We express our gratitude to the referees and the handling editor for their valuable time in helping improve this manuscript. In our opinion, the referees' input will considerably improve the revised manuscript. Here will outline all changes we will add to the initial manuscript. This is our initial response. Planned activities are also included in the document and has all been implemented.

## Responses to Referee 1's Comments

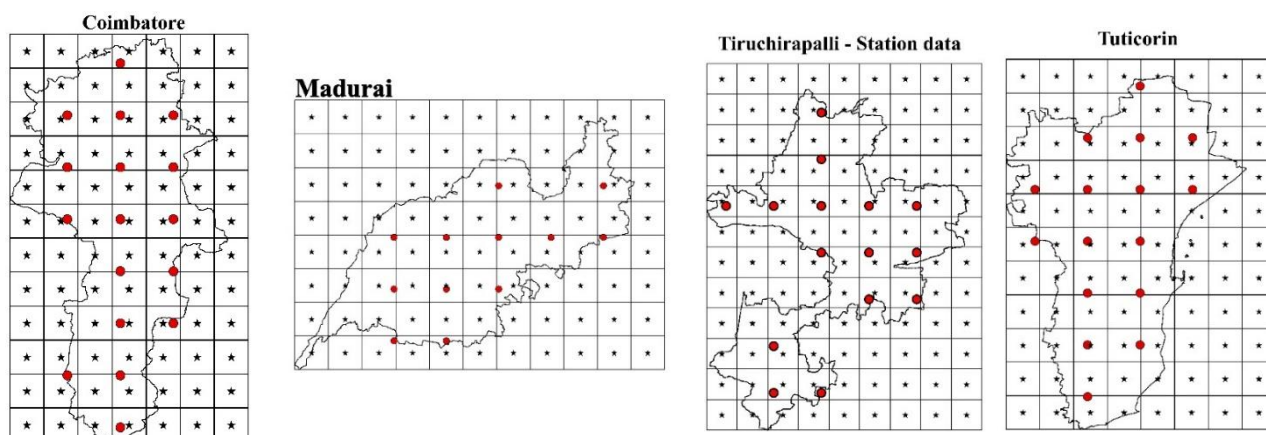
6. **Comment:** Line 253. Doesn't this already introduce a large bias for the data used for validation? In other studies, "point-gridded" is used. Because the location of rain gauges most often does not coincide with gridded precipitation products (GPP) grid centroids, a second strategy was implemented: the point-gridded approach. In practice, a cell is delineated around each rain gauge (cell size of 0.04, 0.05, or 0.1°... depending on the GPP; Table. 2). Then, the rainfall value in those new cells was estimated as the area-weighted mean (max. 4) of the GPP grid cells overlapping with the new cell.

**Response:** Previous studies have used interpolated ground station data to evaluate precipitation products ([Liu et al., 2015](#), [Duan et al. 2016](#), [Shukla et al. 2019](#)). Since the real stations are arranged almost in a regular grid, we can expect low interpolation errors. This is also shown by the LOOCV analysis below.

We performed a LOOCV analysis on the linear interpolated data to check for bias or uncertainty in the data. LOOCV was performed on linear interpolation based on assuming that the value of a station was unknown. The unknown station was estimated from the value of the neighbouring stations based on linear interpolation. The analysis was systematically carried out in Python. The results of the LOOCV analysis represent the mean RMSE at a monthly timescale, which includes both monsoon and non-monsoon months. The RMSE and %MAE of LOOCV analysis produced lower values, indicating minimal uncertainty due to the linear interpolation. Hence, we proceeded with linear interpolation of station data before grid-to-grid comparison.

**Figure: Linearly interpolated grids (0.1°) of the study regions along with the station data.**

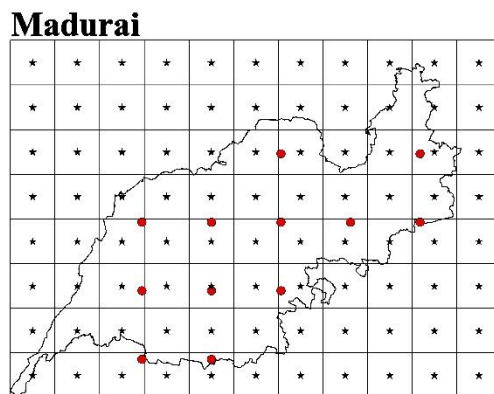
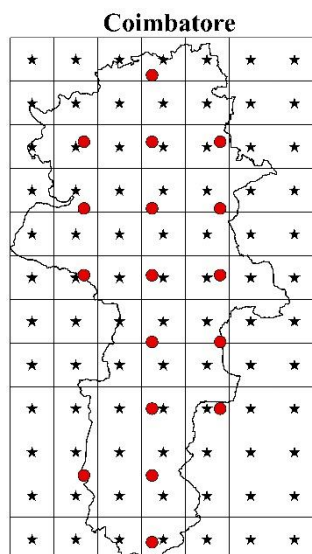
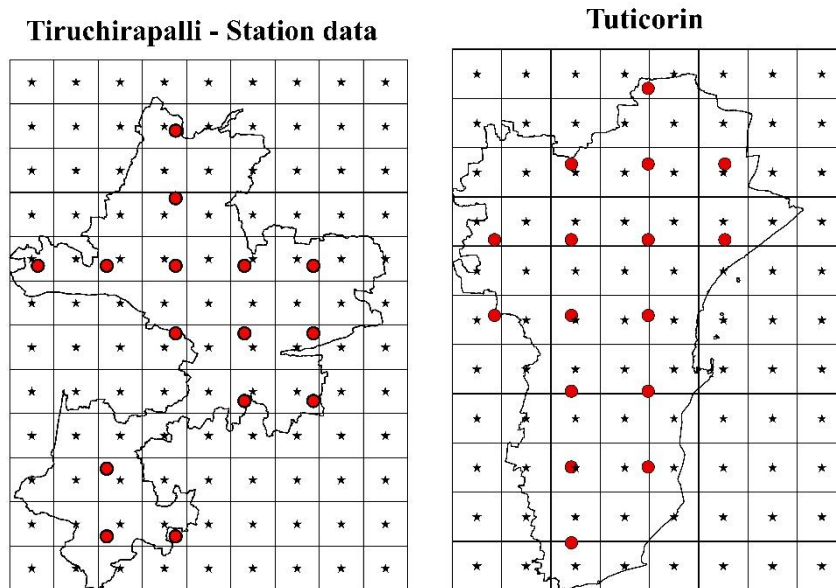
- Comment:** Station to grid comparison: The authors assert that station to grid comparisons are difficult and conduct 'linear interpolation' from station to grid and from product grid to a common 0.1x0.1 degree comparison. I find the overall description of this vague and am also not entirely convinced that this solves the problem given that a lot of the variability within each grid-cell is due to topography and localized patterns that don't change linearly. I am also concerned/ confused that the authors only consider stations within the district for the regional/ district comparison. Given the irregular shape additional stations outside the region should also be considered.

- 8. Comment:** L253: "The interpolated 0.1degree station dataset was used as ground truth to evaluate all the other precipitation products" > See my general comment. Also, it would be really good if the authors could come up with a way to provide any kind of quality measure for this. For example, the authors could have reserved some stations for verification of that methodology. Or conduct a leave-one-out cross-validation to assess how well the interpolated data reflects actual precipitation in that location.

**Response:** Previous studies have used interpolated ground station data to evaluate precipitation products (Liu et al., 2015, Duan et al. 2016, Shukla et al. 2019). The study considered stations distributed both inside and on the boundary of the study region, ensuring a comprehensive representation of precipitation within the region. While the irregular shape of the region could suggest including external stations, this was not feasible due to the poor distribution of meteorological stations in surrounding areas during the study period. The surrounding districts lacked research institutes and Agricultural Universities, which were essential for maintaining meteorological stations and providing reliable data. Since the real stations are arranged almost in a regular grid, we can expect low interpolation errors. This is also shown by the LOOCV analysis below.

In the figure above, red points denote the distribution of station datasets. The grids and the stars represent the linear interpolation. Only grids that are surrounded by at least one rain gauge station were included in the analysis to avoid uncertainties in the analysis. A similar explanation has been addressed to Comment No: 8.

**Response:** As per the Reviewer's suggestion, Leave-One-Out Cross Validation was conducted to assess how well the interpolated data reflected the actual precipitation. LOOCV was performed on linear interpolation based on assuming that the value of a station was unknown. The unknown station was estimated from the value of the neighbouring stations based on linear interpolation. The analysis was systematically carried out in Python. The results of the LOOCV analysis represent the mean RMSE at a monthly timescale, which includes both monsoon and non-monsoon months. The RMSE and %MAE of LOOCV analysis produced lower values, indicating minimal uncertainty due to the linear interpolation. Hence, we proceeded with linear interpolation of station data before grid-to-grid comparison.

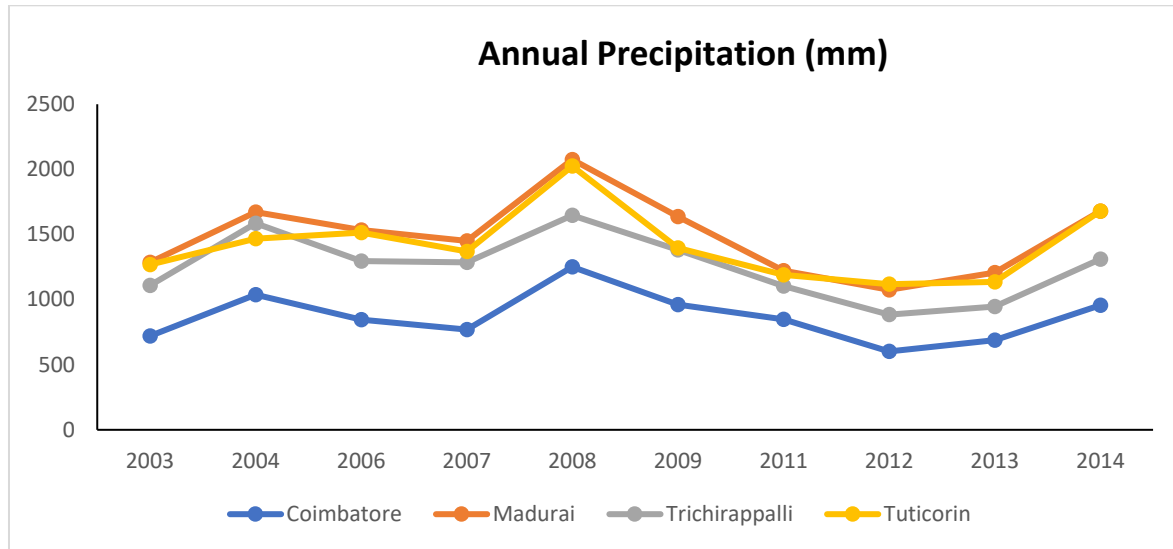
**7. Comment:** ~~precipitation~~

**Response:** Required changes will be made in the revised manuscript (Line 116).
